**SUBMITTAL OF HANFORD FACILITY RESOURCE CONSERVATION AND RECOVERY ACT PERMIT MODIFICATION NOTIFICATION FORM 24590-LAW-PCN-ENV-18-001**

**Hanford Facility RCRA Permit Modification Notification  
Form 24590-LAW-PCN-ENV-18-001**

The purpose of this Class 1 prime modification is to replace the following P&IDs in Appendix 9.2 of the DWP:

Appendix 9.2			
Replace:	24590-LAW-M6-LCP-00001005, Rev 0	With:	24590-LAW-M6-LCP-00001005, Rev 1
Replace:	24590-LAW-M6-LCP-00002002, Rev 0	With:	24590-LAW-M6-LCP-00002002, Rev 1

24590-LAW-M6-LCP-00002002

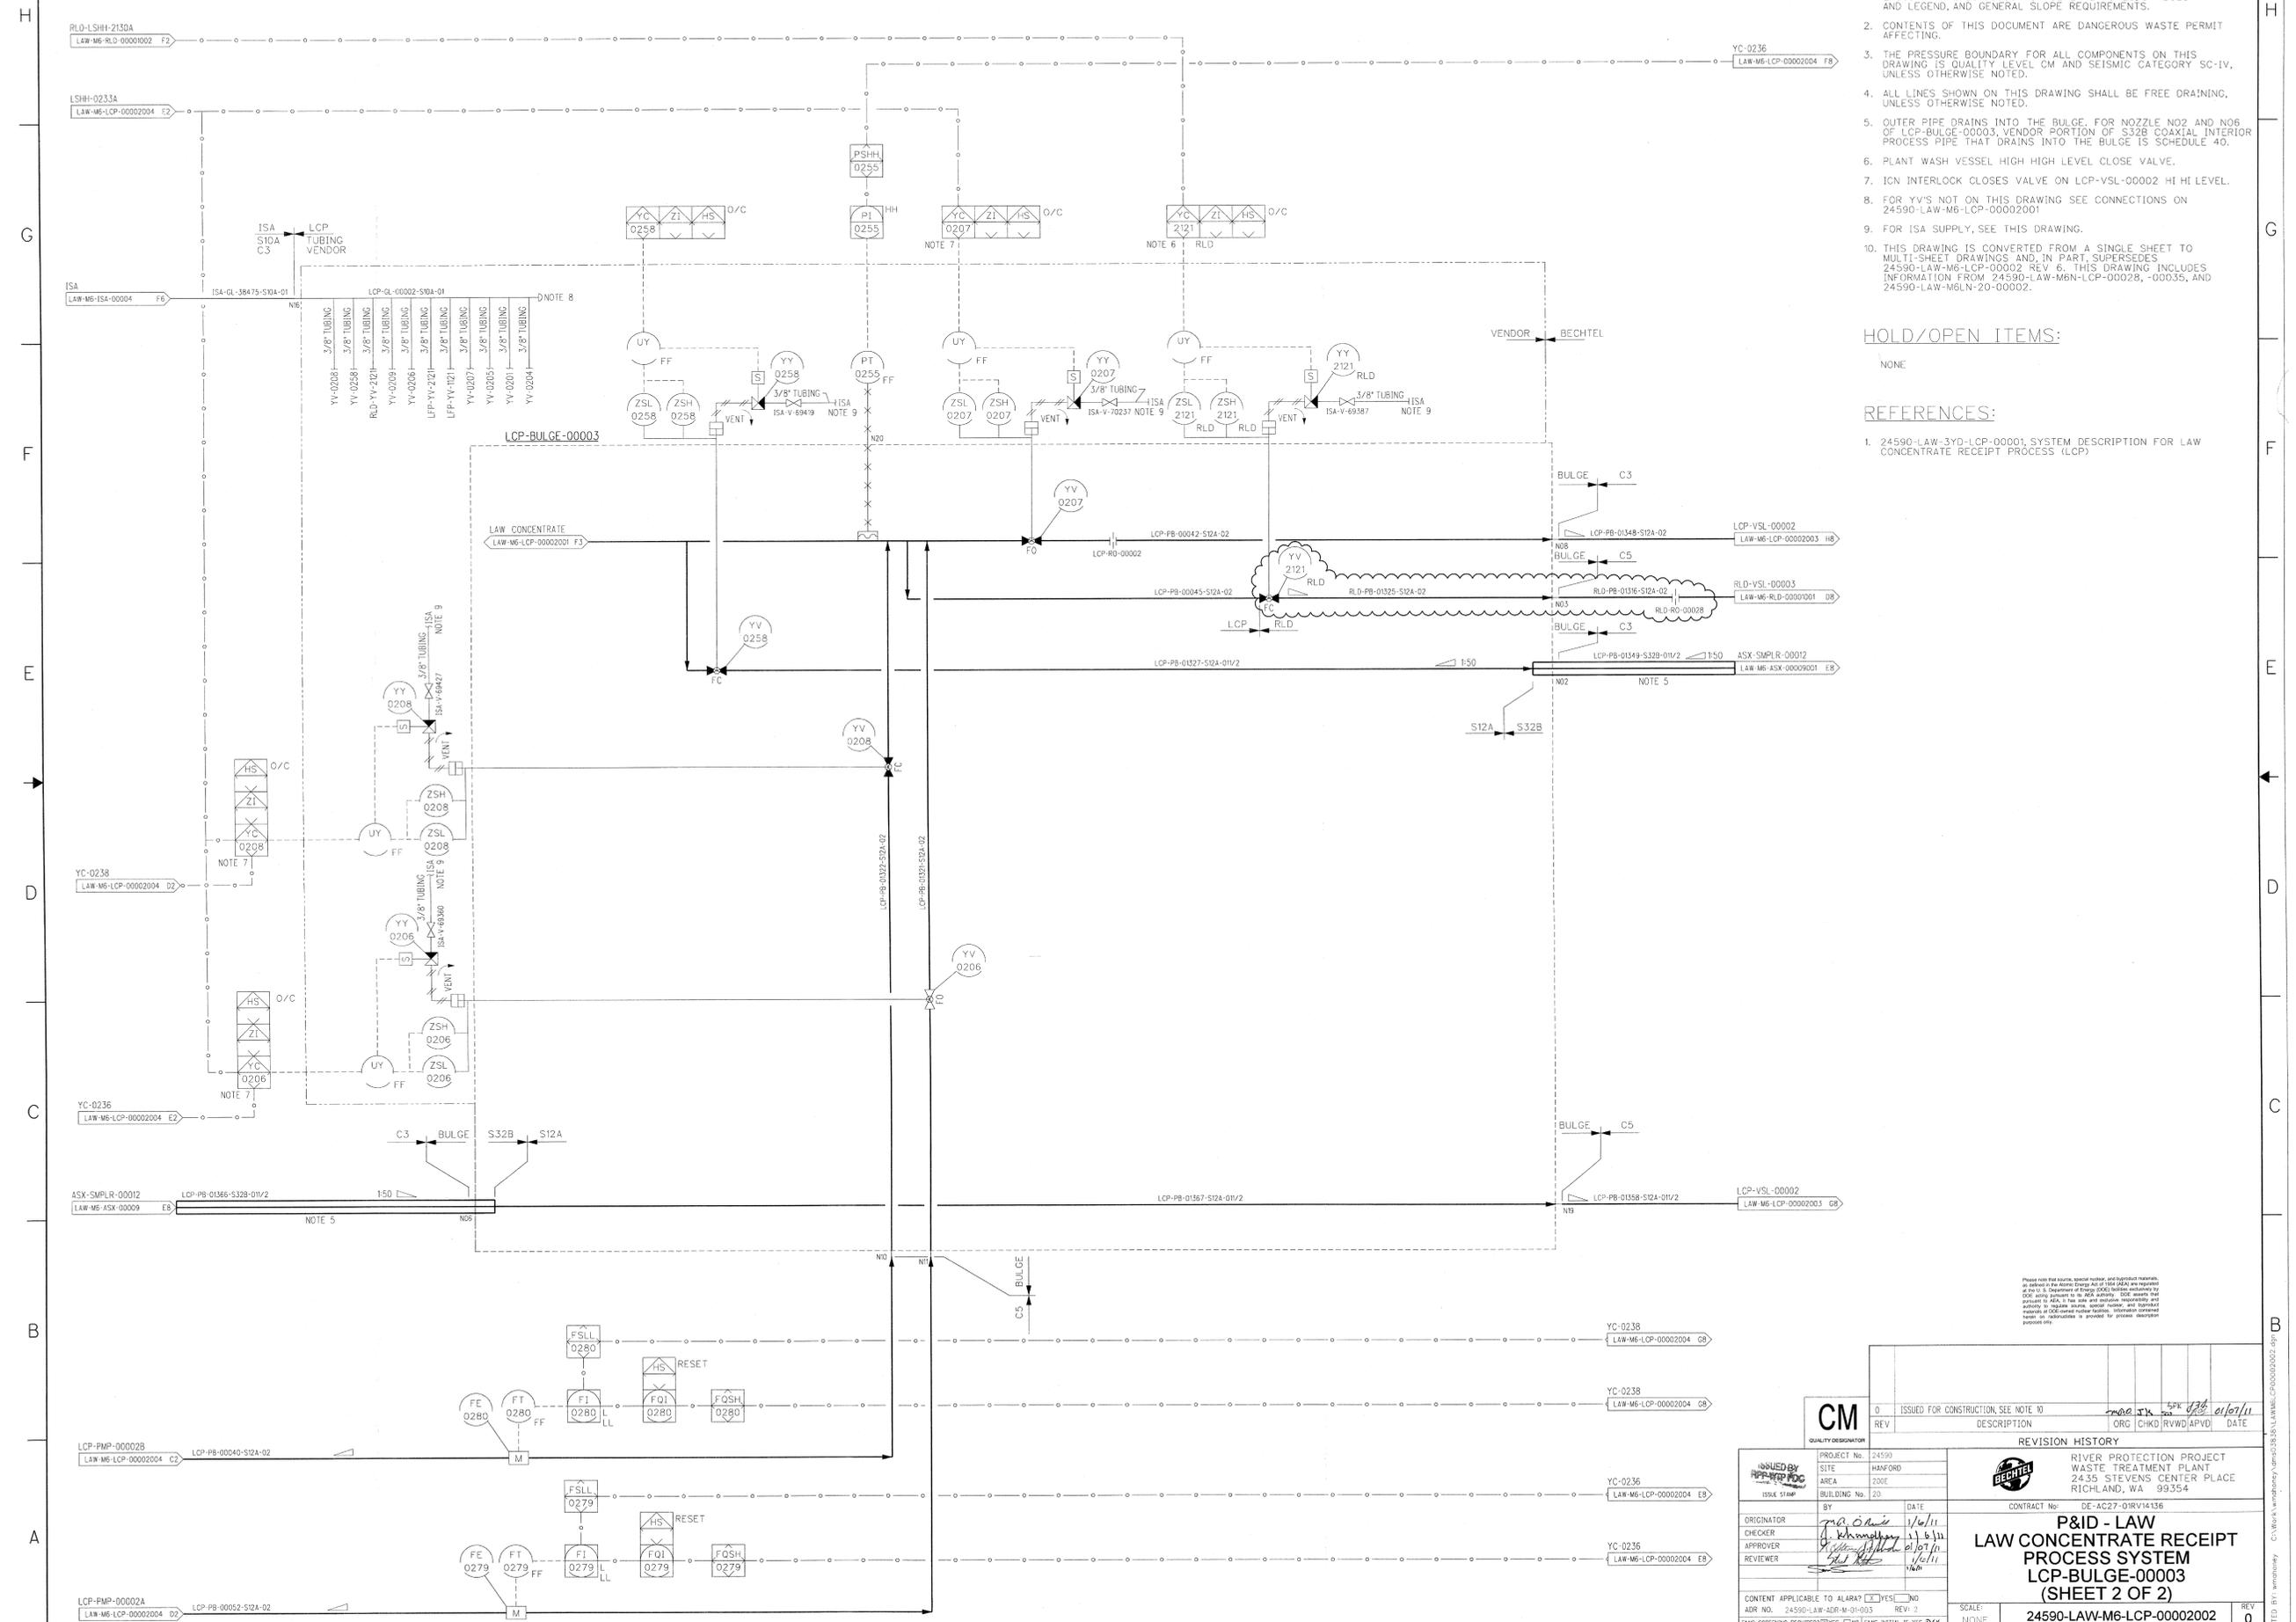
Changes to the P&ID (24590-LAW-M6-LCP-00002002, Rev 1) for the LAW Concentrate Receipt Process System (LCP-BULGE-00003) are summarized below:

- Added or modified the notes section. Revised the References section.
- Added restriction orifices on LCP-RO-00006 outside bulges to restrict cavitation (Grid F3)
- Incorporated internal system designation for LAW-M6-LCP-00002001 (Grid H8)
- Added internal system designation for high flow rate device (Grid B7)
- Revised quality designator from CM to Q at ASX coaxial pipe to bulge interface (Grid B7 and E3)
